CABINET MEMBER FOR ENVIRONMENT – 26 MAY 2020

A424 - FULBROOK TO IDBURY - PROPOSED 50MPH SPEED LIMIT

Report by Interim Director of Community Operations

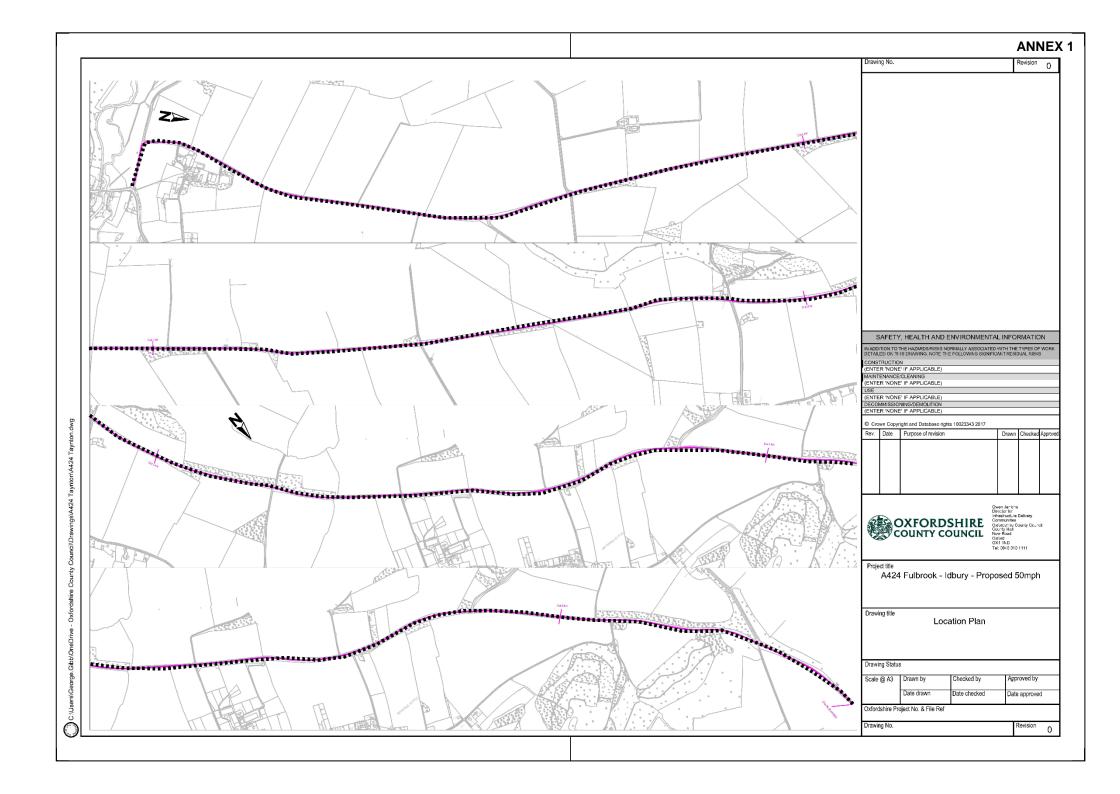
4. The above proposals as shown at Annex 1 have been put forward following a review of the recent accident history – including several accidents resulting in fatal injury – and, if approved, would be funded by the Road Safety budget within the County Council's Capital programme.

- 9. Three objections were received from members of the public citing concerns that the proposed 50mph speed limit was not needed and could be counterproductive if it resulted in an increased number of hazardous overtaking movements by road users frustrated by the slower speed of vehicles ahead complying with the proposed limit. One of these responses expressed concerns specifically on the approximately 2.5km length of the route north of the Tangley Farm junction, which they considered to be suitable for the current national speed limit given the comparatively straight alignment of the road and which they considered provided safe overtaking opportunities, noting also that no proposal has been made for a 50mph on the adjoining part of the route within Gloucestershire.

- 10. A response was also received from a member of the public which while not expressing an objection raised concerns that the a 50mph speed limit would not be effective unless enforced and that a lower (possibly 40mph) speed limit would be appropriate at the junctions along the route. Concerns were expressed also on the need for improved road markings and signing at the junctions in particular.

- 11. Noting the above, 50mph speed limits have been introduced on a large number of rural A class roads, including those with very similar widths and alignments and have found to help reduce accident risks with no evidence of an increased number of accidents involving overtaking. The proposed limit is considered to be consistent with Department for Transport guidelines on setting local speed limits. The introduction of lower speed limits in the vicinity of junctions as suggested by one of the respondents is not considered to be consistent with the above

- 12. The existing traffic signs and road markings particularly those at junctions will be renewed as required as part of the works to implement the speed limit in response to the concerns raised on this matter.
